Access Compliance Report

Public Rights-of-Way

(Curb Ramps)

Intersection ID: N/A	Main Street: HAMILTON_BRIDGE_RD	Cross Street: OBAN_PASSAGE_DR	Location: SE
ADA ID: 29A883DABF12	Ramp Type: Perp	Initial Pass/Fail: Fail	Overall Compliance: No
Severity Score: 58.75			
Codes/Mitigation Info/Possible Solution		Field Measurements/Component Compliance

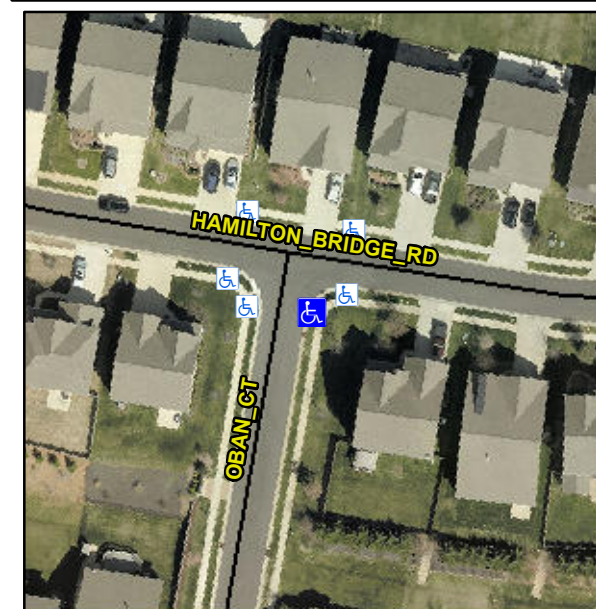
R304.5.1, R304.2.2, R304.5.3

Compliance	Description	Data	Compliance	Description	Data
N/A	Ramp Length (in)	47.0	No	Ramp Slope (%)	15.1
No	Ramp Width (in)	45.0	No	Ramp XSlope (%)	7.9
N/A	Flare Type LT	N/A	N/A	Flare Type RT	N/A
N/A	Flare Slope LT (%)	N/A	N/A	Flare Slope RT (%)	N/A
N/A	Flare Traversable LT?	N/A	N/A	Flare Traversable RT?	N/A
N/A	Landing Length (in)	N/A	N/A	DWS Provided?	N/A
N/A	Landing Width (in)	N/A	N/A	DWS Contrast?	N/A
N/A	Landing Slope (%)	N/A	N/A	DWS Length (in)	N/A
N/A	Landing X Slope (%)	N/A	N/A	DWS Full Width?	N/A
N/A	Landing Curb? (Y/N)	N/A	N/A	DWS Offset (in)	N/A
N/A	Shared Landing?	N/A			
N/A	Gutter Ponding?	N/A	N/A	Gutter Slope (%)	N/A
N/A	Gutter Lip Ht (in)	1.0	N/A	Gutter X Slope (%)	N/A
N/A	Painted X Walk1?	No	N/A	Painted X Walk2?	N/A
	X Walk 1 Direction	To W		X Walk 2 Direction	N/A
N/A	X Walk 1 Width (in)	N/A	N/A	X Walk 2 Width (in)	N/A
	X Walk 1 Slope (%)	1.9		X Walk 2 Slope (%)	N/A
	X Walk 1 X Slope (%)	7.3		X Walk 2 X Slope (%)	N/A

Remove & Replace Entire Ramp.
